ENGINE - 2.0L - REVISED TIMING BELT AND TENSIONER SETUP PROCEDURE

This TSB article is being published to provide correct service procedure for setting up cam timing belt and tensioner, due to the procedure being inaccurate in the Workshop Manual.

Figure 1

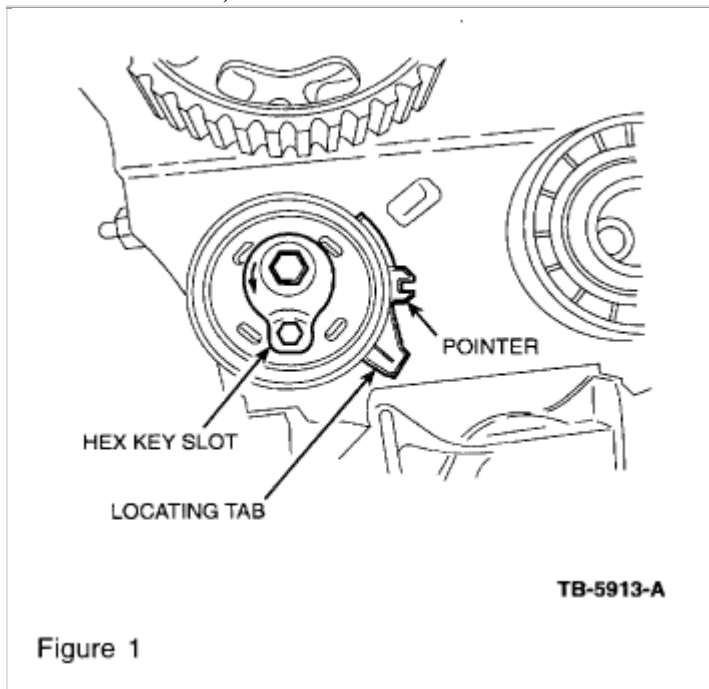
1. Back out the tensioner bolt four (4) full turns and position the tensioner so the locating tab is at approximately the 4 o'clock position. Line up the hex key slot in the tensioner adjusting washer with the pointer that is located behind the pulley (Figure 1).
2. Working counterclockwise from the crank sprocket, install the timing belt.

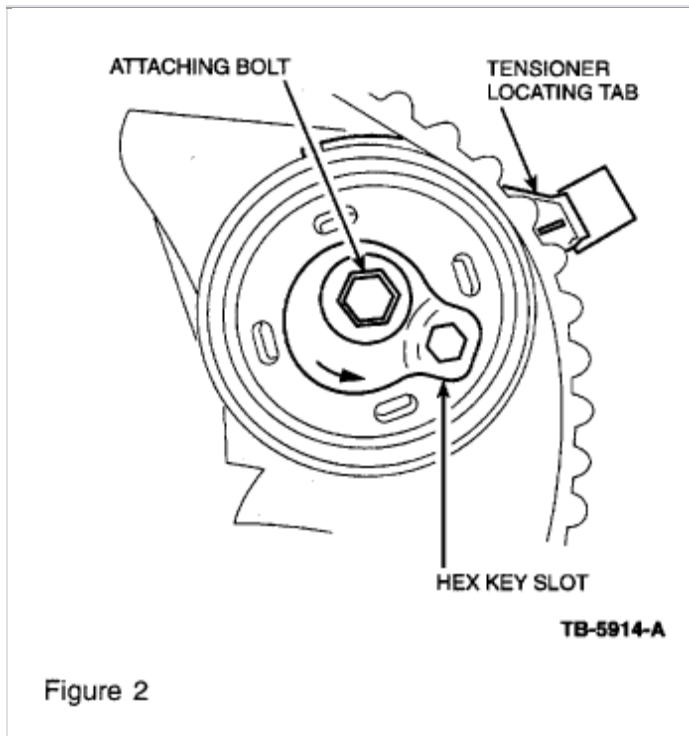
3. Rotate the tensioner locating tab counterclockwise and insert the locating tab into the slot in the rear timing cover (Figure 2).
4. Position the hex key slot in the tensioner adjusting washer to the 4 o'clock position (Figure 2).
5. Tighten the attaching bolt enough to seat the tensioner firmly against the rear timing cover, but still allow the tensioner adjusting washer to be rotated using a 6 mm hex key (Figure 2).

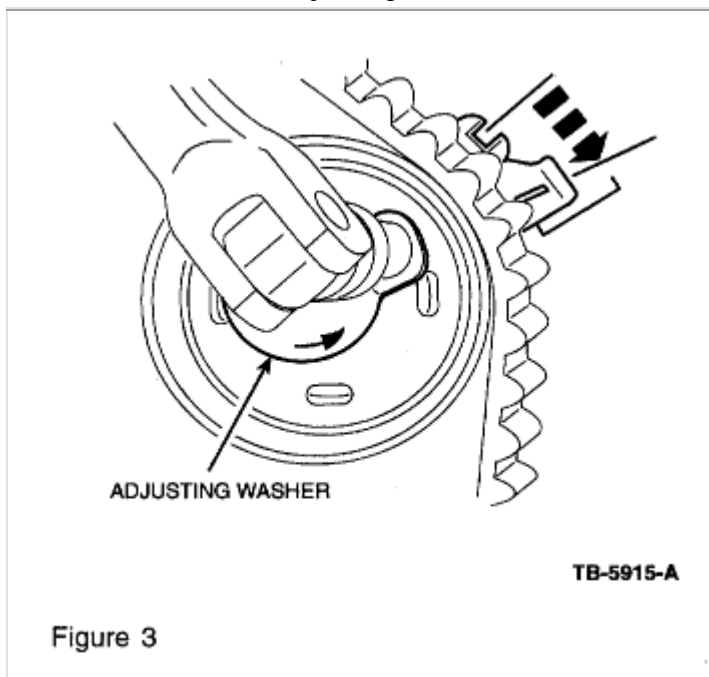
6. Using the hex key, rotate the adjusting washer counterclockwise until the notch in the pointer is centered over the index line on the locating tab. (The pointer will move in a clockwise

direction during adjustment) (Figure 3).

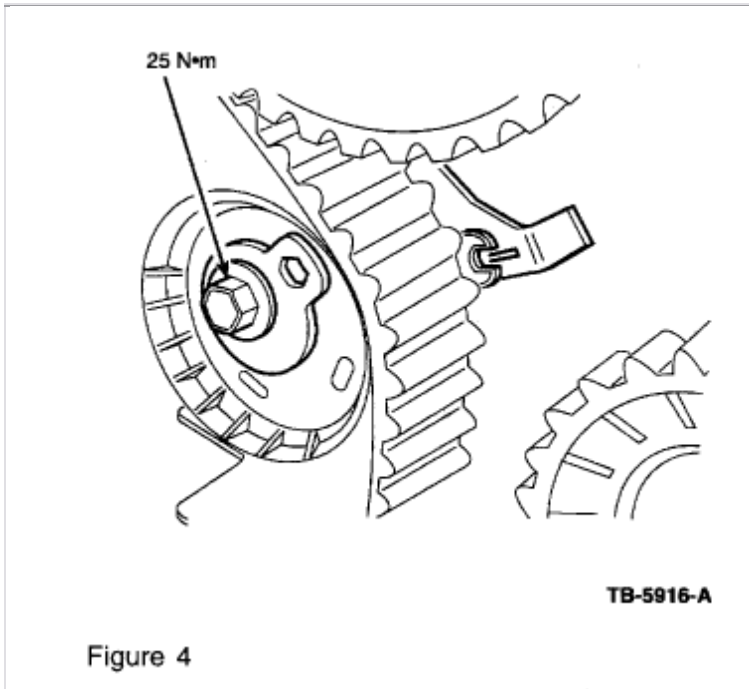
7. While holding the adjusting washer in position, torque the attaching bolt to 25 +/- 3 N.m (18 +/- 2 lb-ft) (Figure 4).

**NOTE IF THE POINTER DOES NOT REMAIN CENTERED OVER THE INDEX LINE DURING FINAL TIGHTENING, LOOSEN THE BOLT AND REPEAT THE PROCEDURE BEGINNING WITH STEP 4.**
